MEMORANDUM

SUBJECT: Parker and Pine Filing 1, Lot 3 – Slim Chickens Site Plan
Review Comments 01

Subject: Slim Chicken's, Parker – Landscape Comments, 9/4/2020

P4.0

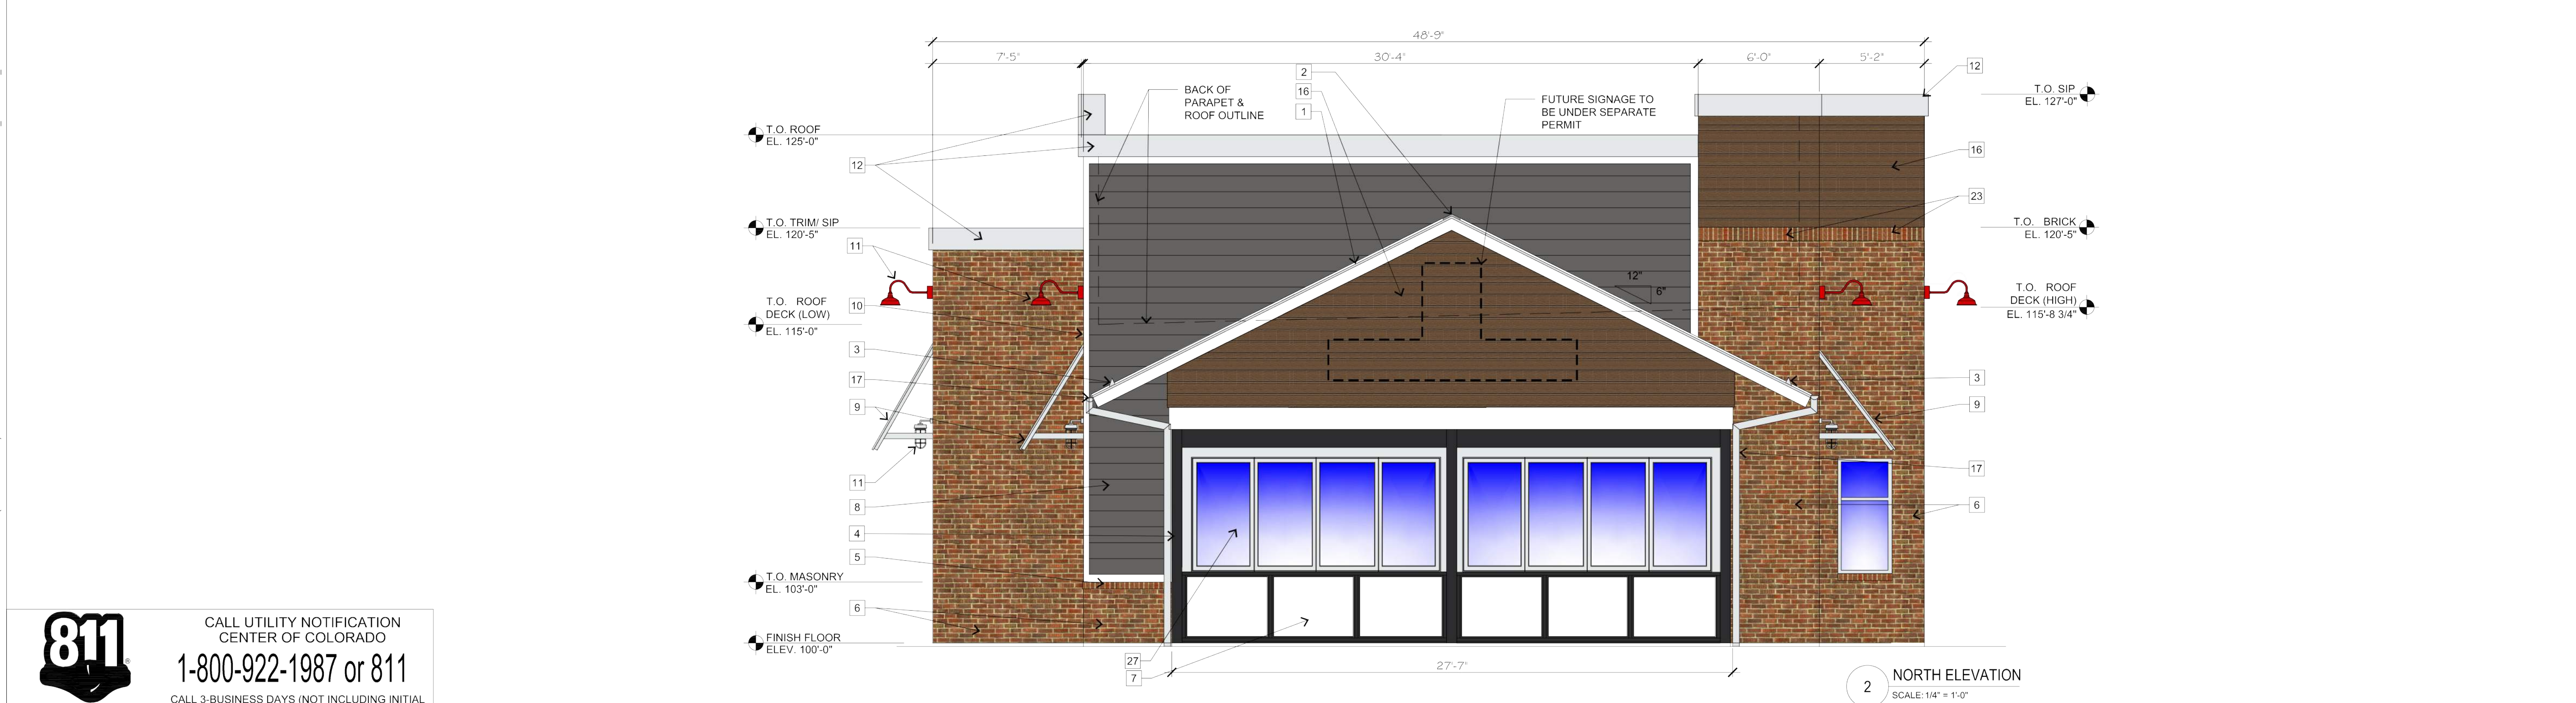
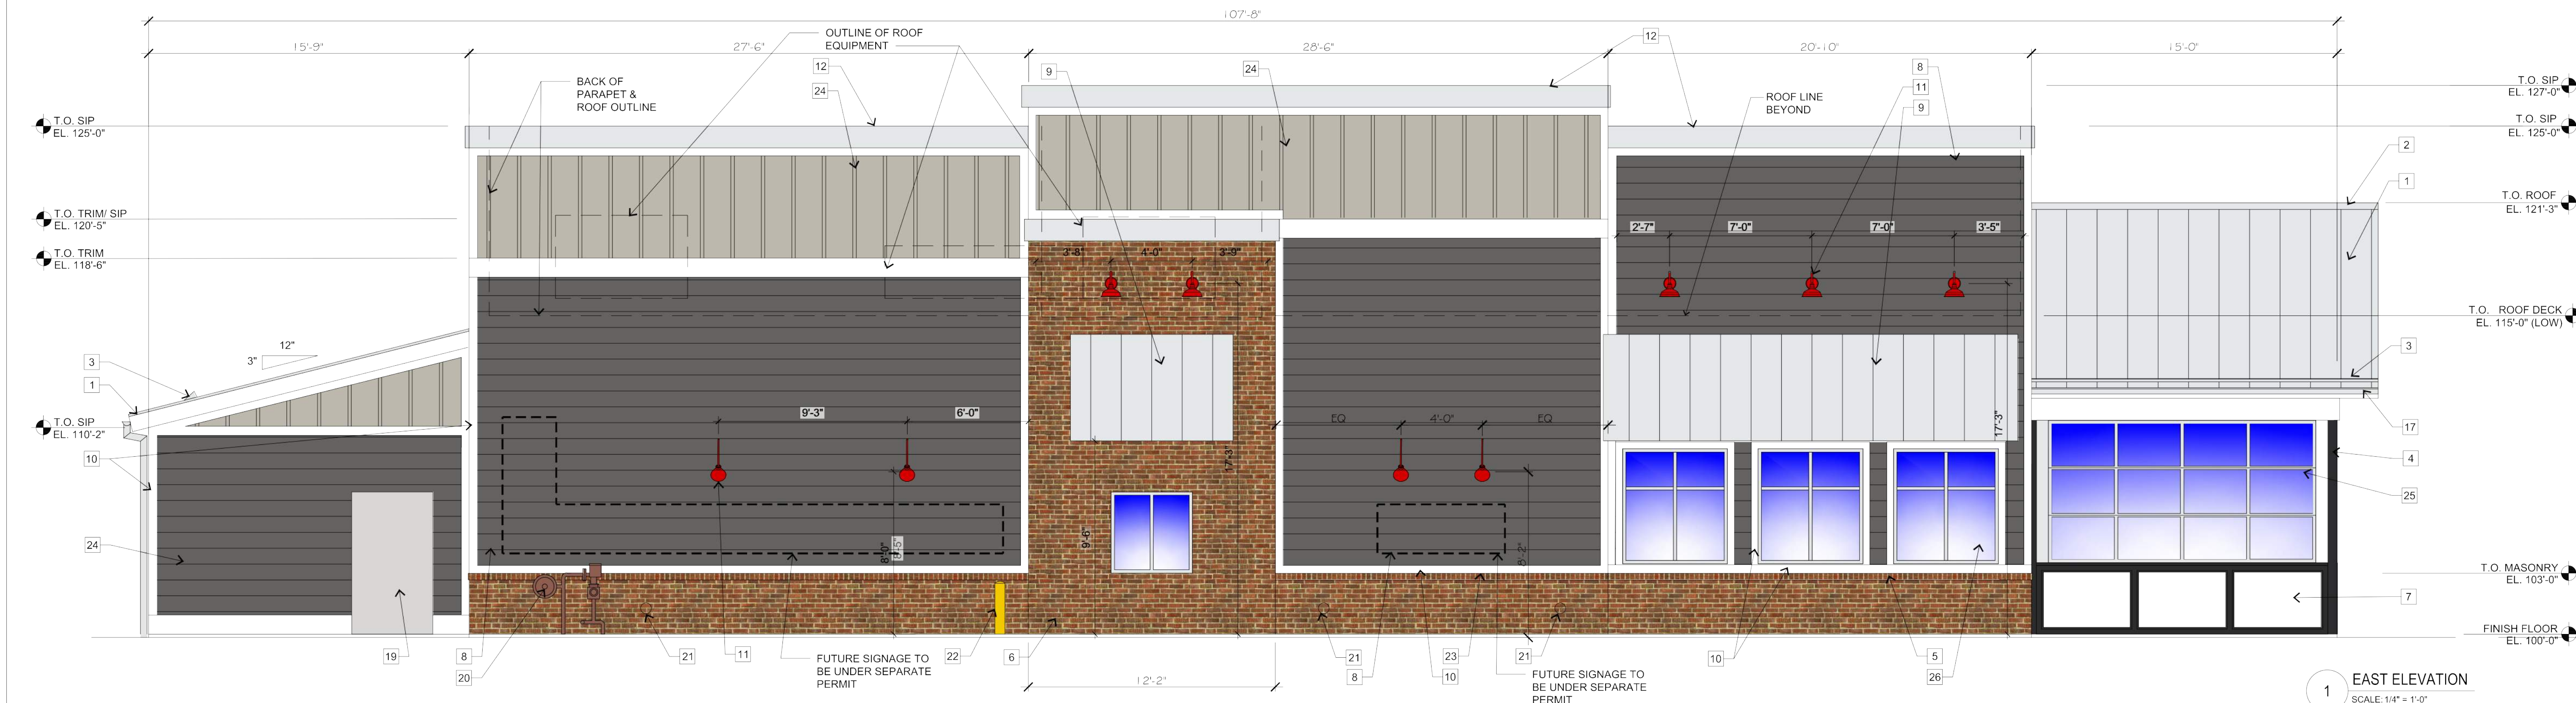
3. All rooftop or ground-mounted mechanicals are to be depicted on the site plan (& Building Elevations). Please revise the site plan to show all mechanicals and how they will be screened. Include dimensions.

1. All rooftop/RTUs or ground-mounted mechanicals must be shown on the building elevations (& site plan) and how they will be screened. Please revise the building elevations to show all mechanicals including dimensions and callout of materials and colors.

Outlines of mechanical equipment have been added to C1.0, P4.0, P4.1. Dimensions are shown on the elevations P4.0, P4.1.

Dashed outlines of mechanical equipment have been added to all elevations. P4.0, P4.1.
